# UNITED STATES PATENT AND TRADEMARK OFFICE

APPLICATION NO.	FILING DATE	FIRST NAMED INVENTOR	ATTORNEY DOCKET NO.	CONFIRMATION NO.
10/616,872	07/10/2003	Rickey J. Thomas	0275Y-000703	1565

**Office Action Summary**

## **DETAILED ACTION**

**Figures**

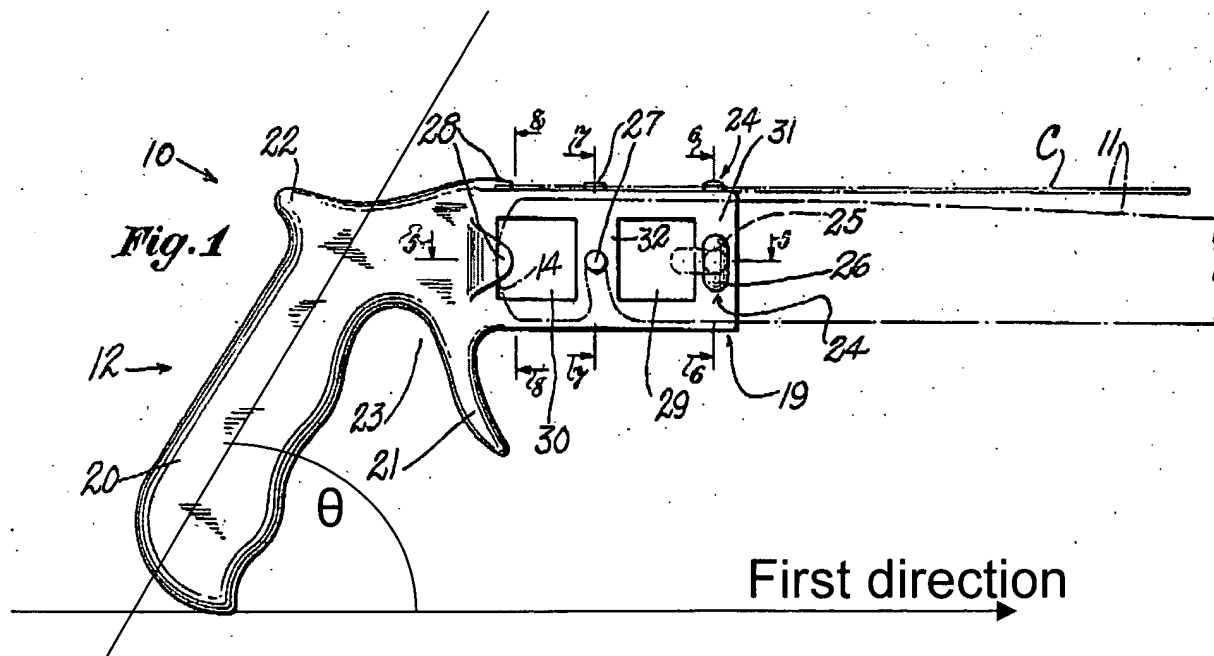
Davey discloses a hand saw (10) as claimed, comprising: a handle (12) including a hand grip portion (20) and first and second blade mounting portions, said hand grip portion defining an inner surface, said first blade mounting portion (including 24 and 27 at A) being disposed on a side surface of said handle and said second blade mounting portion (including 24 and 27 at C) being disposed on a bottom surface of said handle; and a blade (11) removably mounted to either of said first and second blade mounting portions and extending in a first direction (see *Figures* section at the end of this Office action) away from said handle, wherein said inner surface of said hand grip portion is sloped toward said blade so as to be oriented at an acute angle ( $\theta$ , see *Figures*) relative

to said first direction, and wherein said first and second blade mounting portions each include a key (27) adapted to be received in an end slot (15) in said blade.

The inner surface of the hand grip portion can be considered "sloped toward said blade" because the grip is angled from the outer end until it meets the blade mounting portion. Like Applicant's device, a user's hand will be angled downward and toward the blade when holding the grip.
